CLEVE HILL SOLAR PARK

STATEMENT OF COMMON GROUND BETWEEN THE APPLICANT AND LOWER MEDWAY INTERNAL DRAINAGE BOARD

August 2019
Revision A

Document Reference: 12.2.5
Submitted: Deadline 4

Produced By: LN	Ref: 2238-PUB-094
Checked By: MB	Date: 20/08/2019

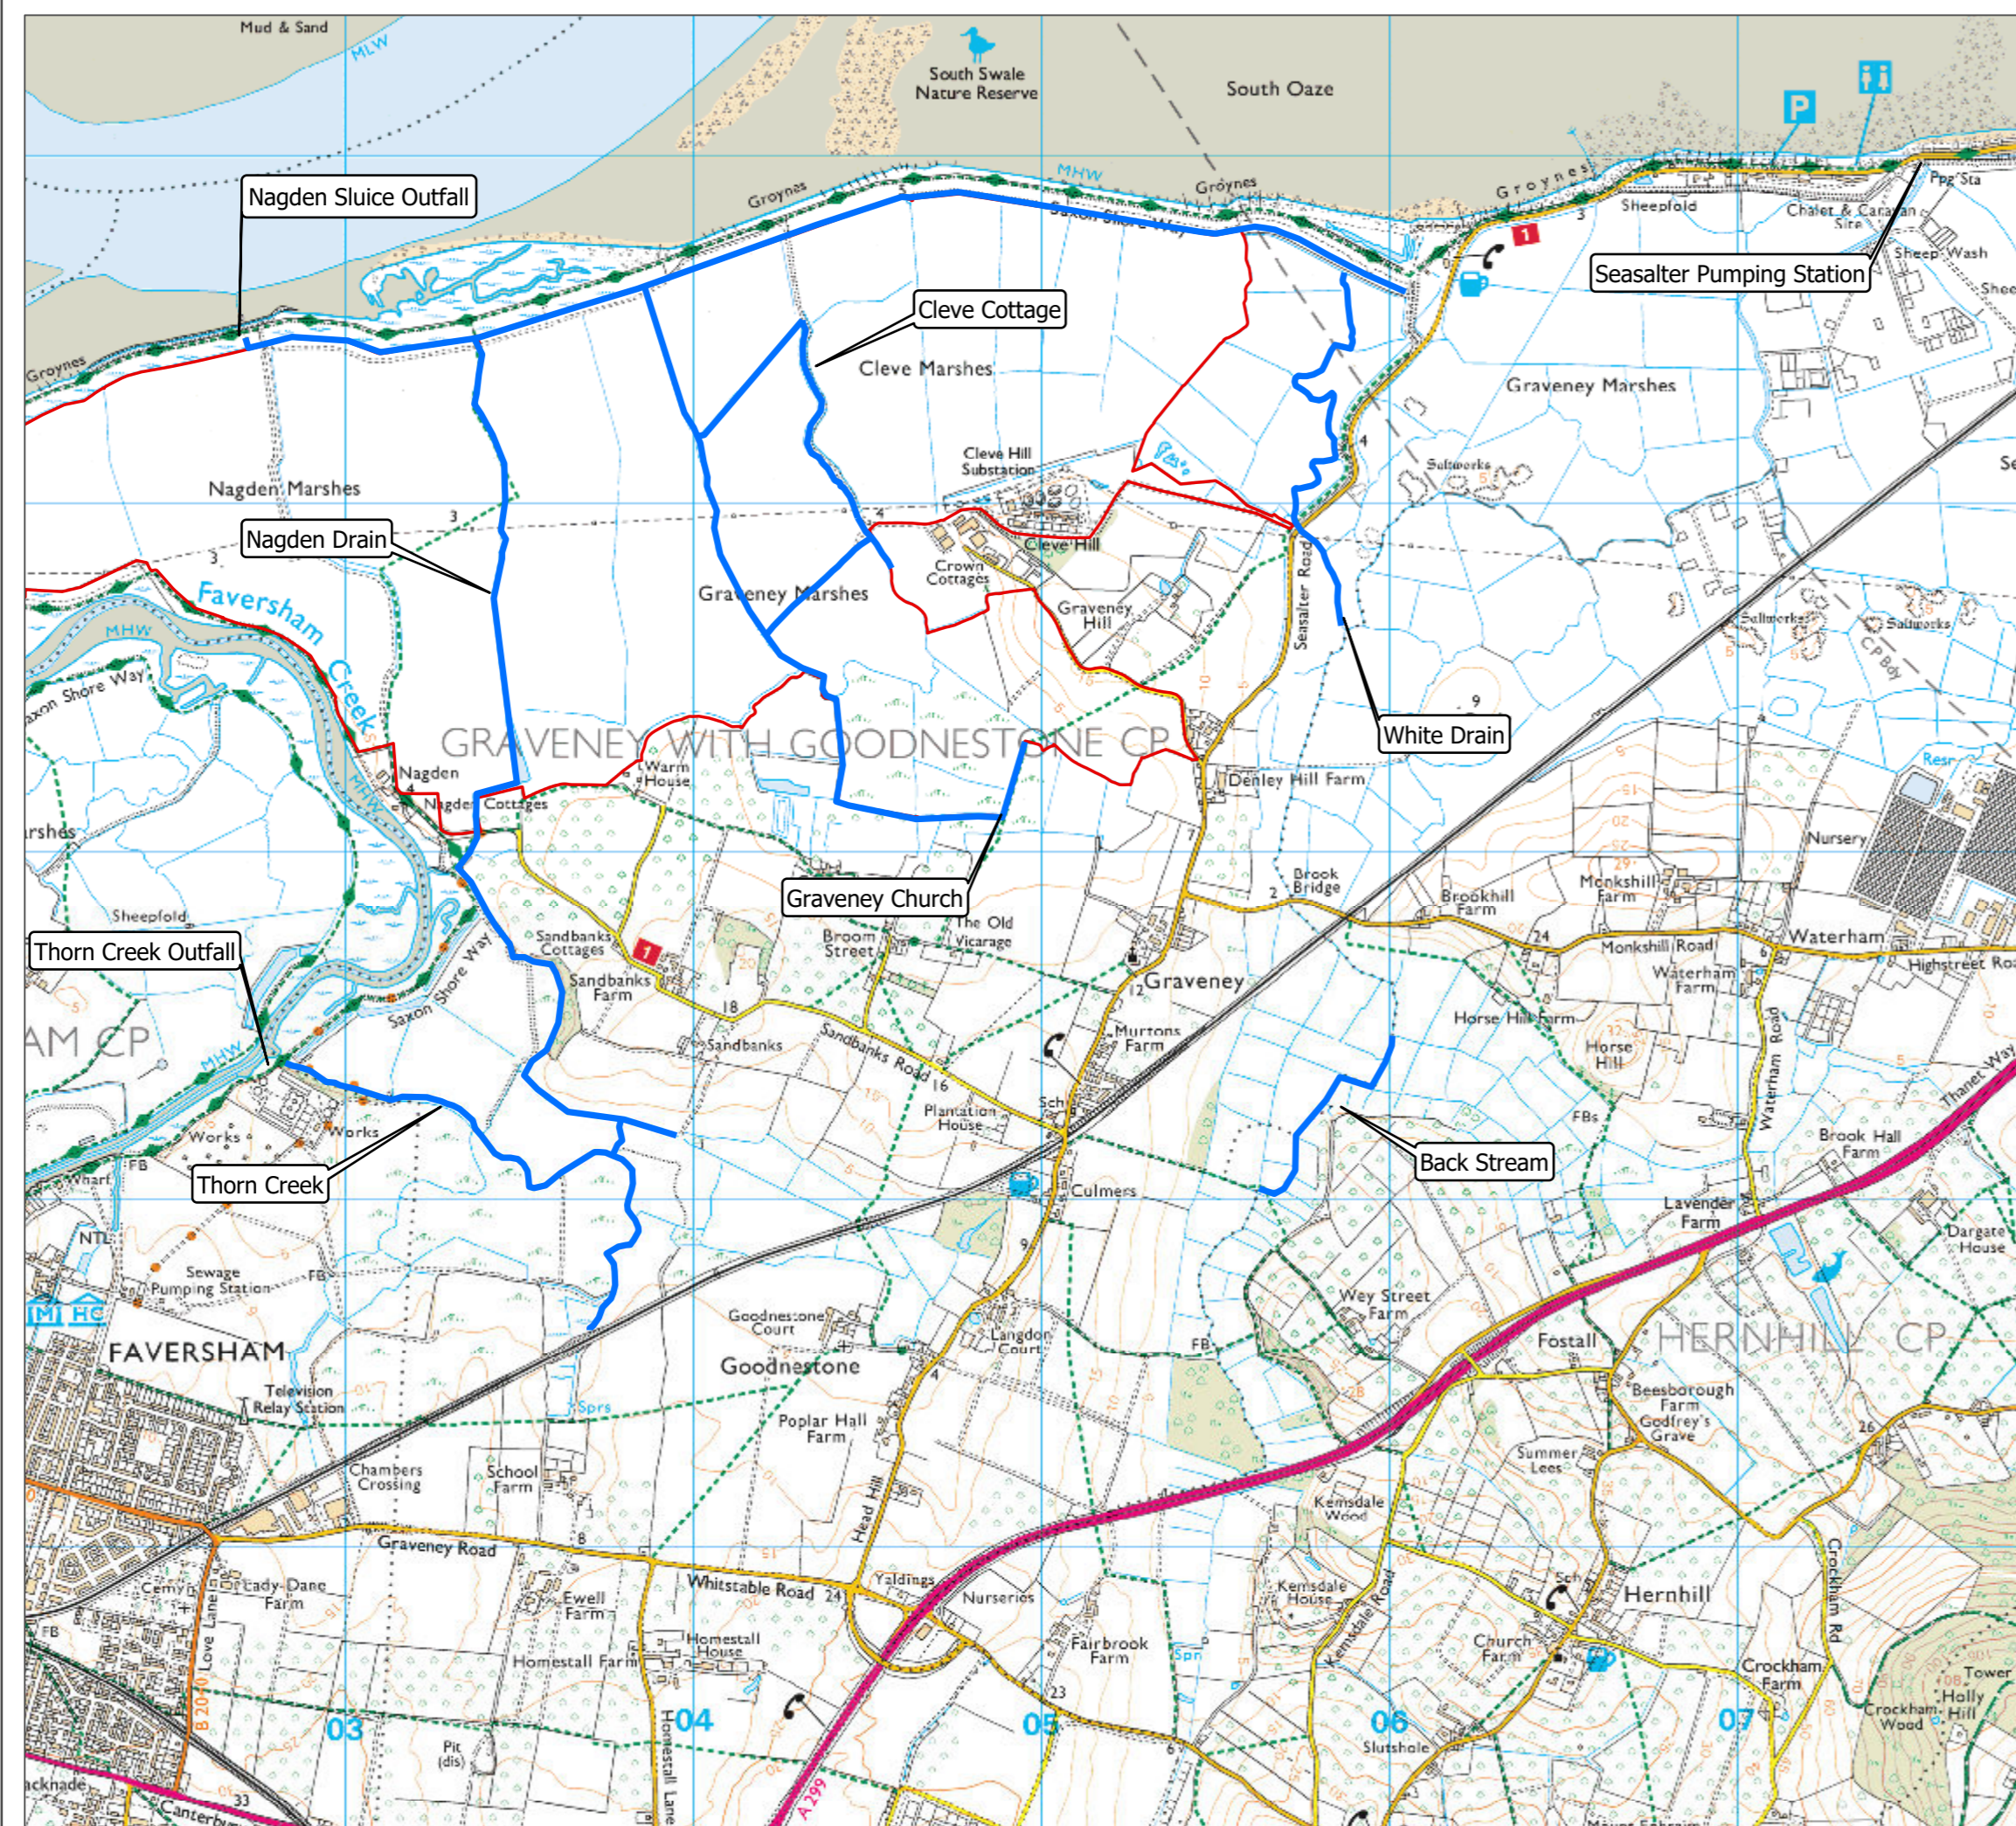
Rule 6 Letter SoCG Request	Applicant's Response	Status (LM IDB to complete)
	<p>262830).</p> <p>Photographs 3 and 4 on Figure 2238-PUB-085 in Appendix A of this SoCG show that existing flow control structures such as sluice gates can isolate the Development area from flows originating in Back Stream watercourse to the southeast of the Site (east of Seasalter Road).</p> <p>Similarly, existing outfalls and flow control structures are operated by Lower Medway IDB on Thorn Creek (LM IDB asset ID 58) to the south west of the Development (in proximity to Thorn Sluice Outfall – operated by the EA² Asset ID: 257358), which can be managed to ensure water levels within the Development can be isolated from levels in the immediate and wider catchment outside the Application site boundary.</p> <p>As such, raising water levels onsite via the existing flow control infrastructure and via non-return valves or sluice gates will not lead to an unacceptable change to the hydrological regime offsite.</p> <p>It is proposed that a detailed method statement will be submitted to the IDB and the HMSG for approval prior to the works being undertaken, as part of a Land Drainage Consent Application.</p> <p>Any initial works to construct infrastructure to alter water levels within watercourses, such as the installation of drop boards sluices, will require Land Drainage Consent from the LM IDB. This consent will be applied for alongside the discharge of Requirements 2 (h) 8 and 10 of the dDCO.</p> <p>The Applicant seeks agreement from the LM IDB that the proposed water level management and arrangements for works within watercourses as set out above will not have an adverse effect on offsite hydrology and water management and are therefore acceptable.</p> <p>Drains and control structures (such as outfalls) are labelled on Figure</p>

Rule 6 Letter SoCG Request	Applicant's Response	Status (LM IDB to complete)
	2238-PUB-094 within Appendix A of this document.	
<p>Assessment of hydrological, water quality, water resource and wildlife effects, including but not limited to surface water crossings, run-off, the risk of flooding, and contamination of surface and groundwaters: to include mitigation measures, including likely effectiveness, monitoring procedures and how mitigation will be secured within the DCO.</p>	<p>An assessment of potential effects on the hydrological environment is provided within Chapter 10 - Hydrology, Hydrogeology, Flood Risk and Ground Conditions of the ES [APP-040].</p> <p>The Flood Risk Assessment (FRA) submitted with the Application [APP-227] provides an assessment of flood risk and the potential for increased run-off rates as a result of the installation of the Development, along with the requirement of attenuation Sustainable Drainage Systems (SuDS).</p> <p>Good construction practice embedded in the design of the Development and further mitigation measures in are outlined within the latest version of the Outline CEMP [REP3-006].</p> <p>As identified in Section 10.4 Embedded Development Design of Chapter 10 - Hydrology, Hydrogeology, Flood Risk and Ground Conditions of the ES [APP-040], the effectiveness of construction practice and buffer distances has been demonstrated on large scale construction projects that Arcus has advised on.</p> <p>Water quality monitoring is proposed to provide an indication of the effectiveness of construction good practice and this is outlined in Section 8 Monitoring Programme of the latest version of the Outline CEMP [REP3-006].</p> <p>The requirement for water quality monitoring and construction good practice will be secured through Requirement 10 of the DCO.</p> <p>The Applicant seeks agreement from the LM IDB that the assessments</p>	<p>Water quality, ground water and monitoring will need to be agreed by the EA.</p> <p>The LMIDB are only concerned with the land drainage aspects of the site</p>
